DUNE-SP

Technical Integration

- Cold Electronics Tees
- Pivot Points for HV Latches
- Annotations for PD & APA

June 25, 2020

CE Tees, 8760087 and 8760088

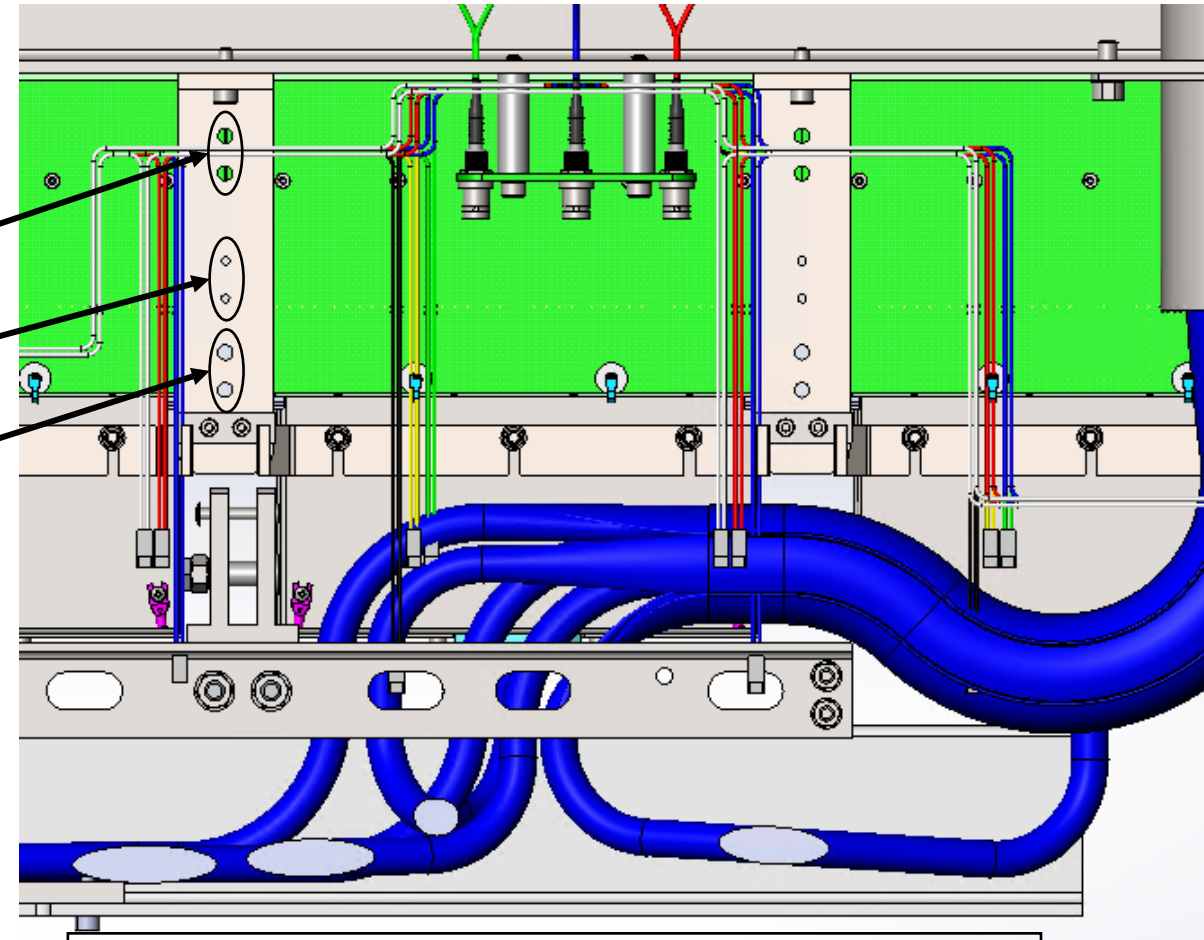
- Key Functions
 - Connects CE bracket to the APA head tube
 - Tie down points for APA bias voltage cable bundle
 - Available connection point for CE box ground strap
 - (New) Available tie down points for CE cables, lower APA
- Radius added to alleviate concerns of the potential to damage cable.
- Note: CE cable bundle shown in images does not completely represent MZ plans (work in progress at BNL)

Section view shows the space behind CE boxes at the head tube of the lower APA

Pivot Points for HV Latches, 8760258 and 8760239 (1/2)

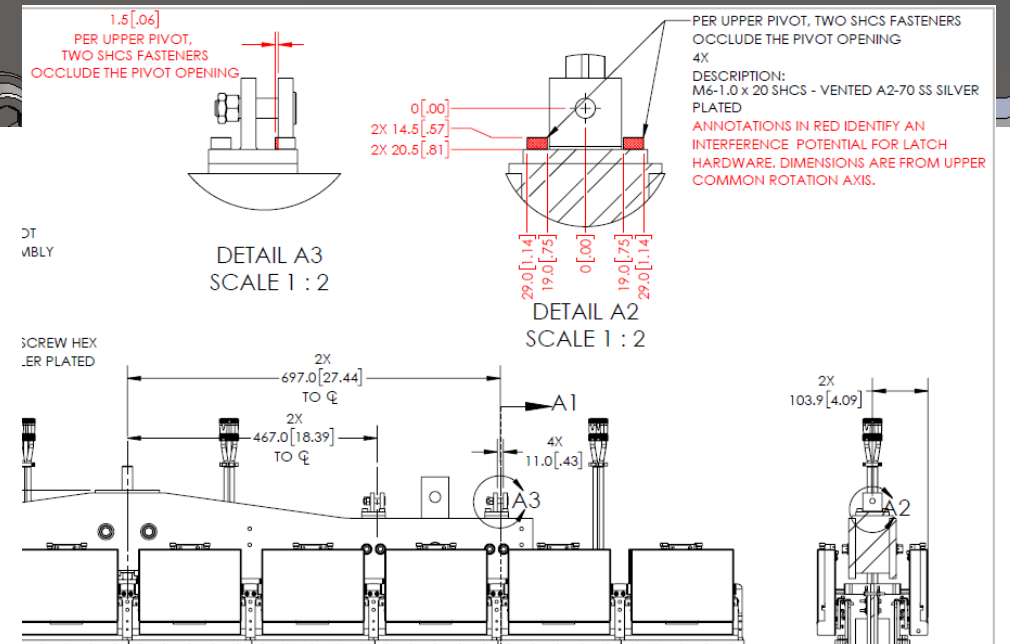
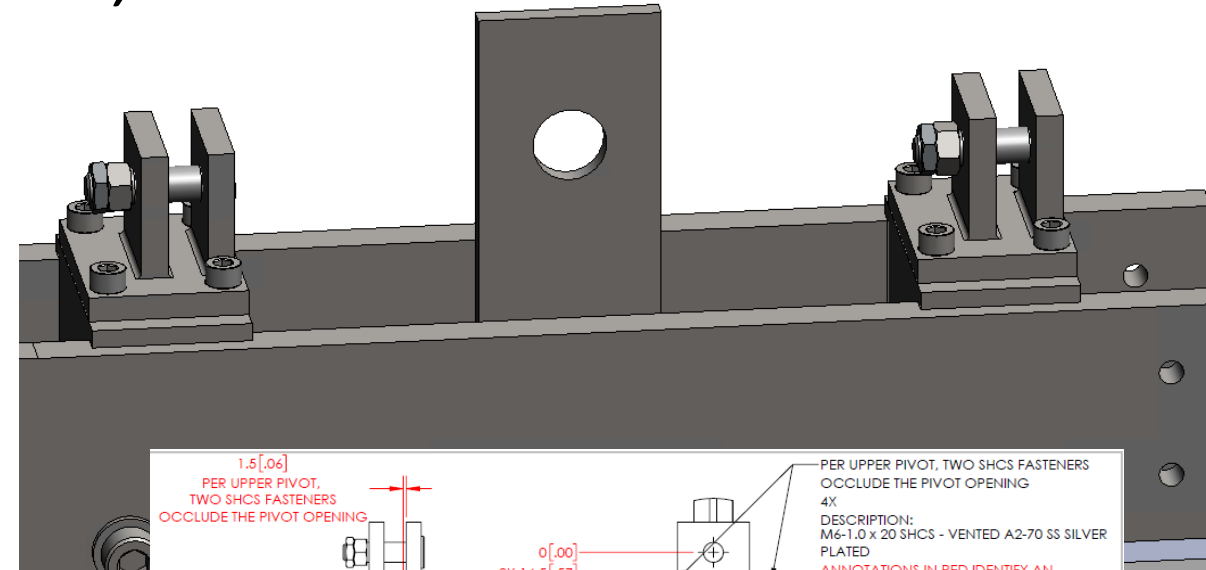
- It was deemed desirable to have the latches at one half the detector pitch.
- The opening between pivots now measures 11mm.
- Pivot points for HV latches are located on the APA pair
 - 8706258 can be found on the **upper APA**
 - 8760239 can be found on the **lower APA**
- 8760258 can no longer be referred to as symmetric due to the HV needs and close proximity of the CE cable tray.
 - Note a potential for interference has been highlighted within interface drawing 8760307.

Pivot Points for HV Latches, 8760258 and 8760239 (2/2)

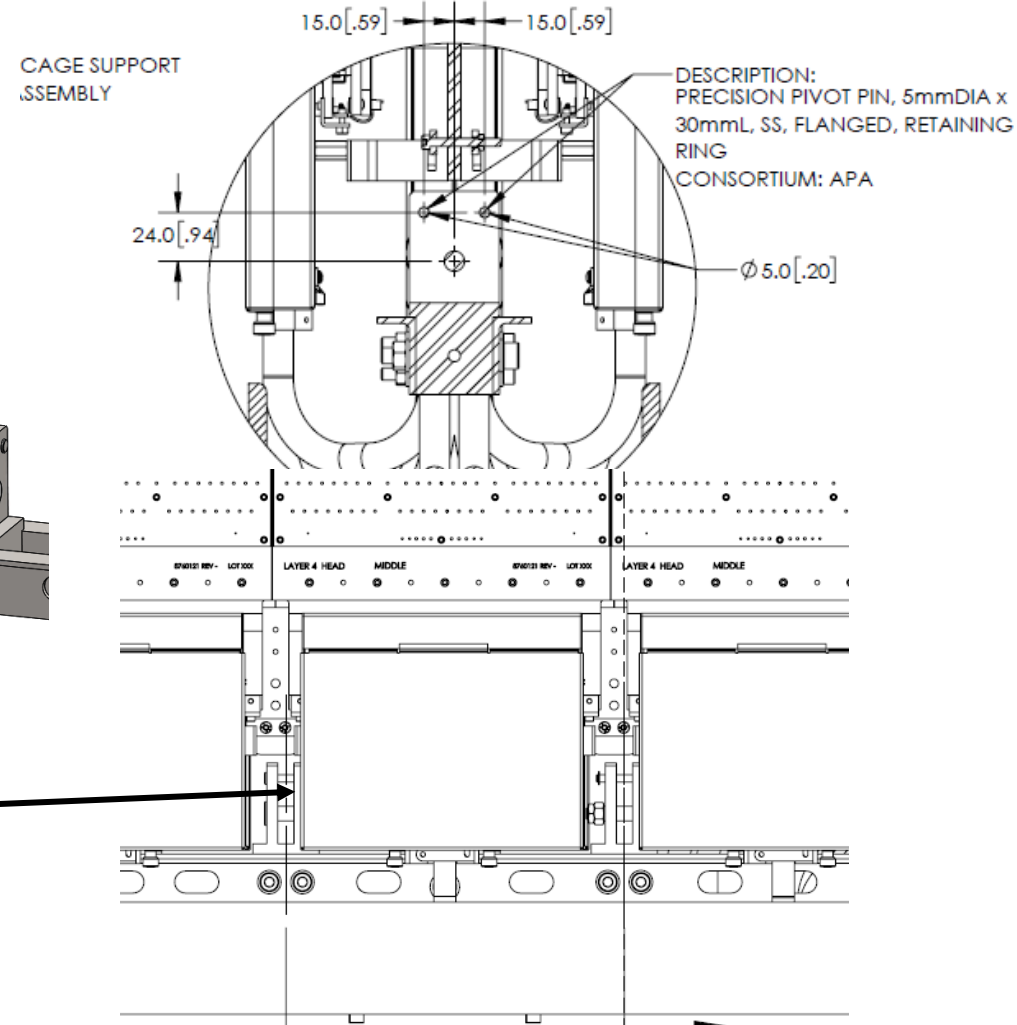
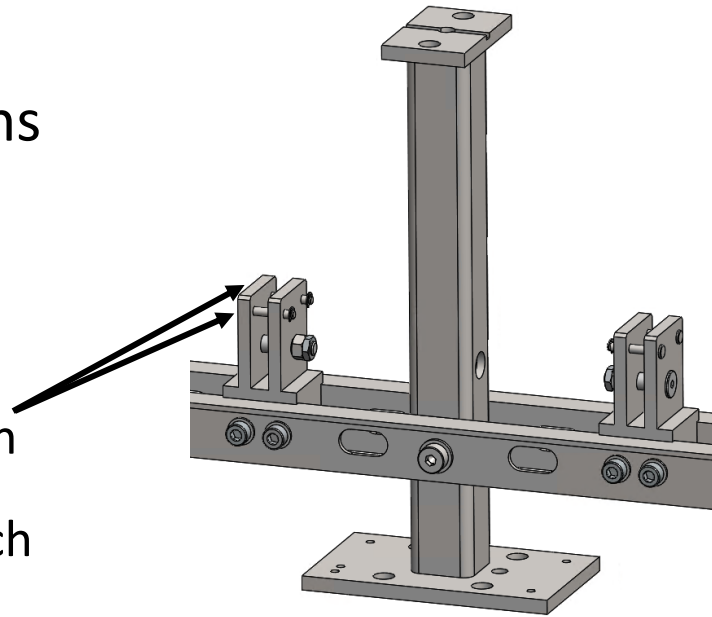
- 8760239 remains symmetric. Modifications to other APA components have facilitated the adjustment.
 - The addition of precision pivot pins create a physical stop for the latch at pre deployment.
- The latch now has a ~5mm clearance to the nearest CE box (this was previously ~10mm)
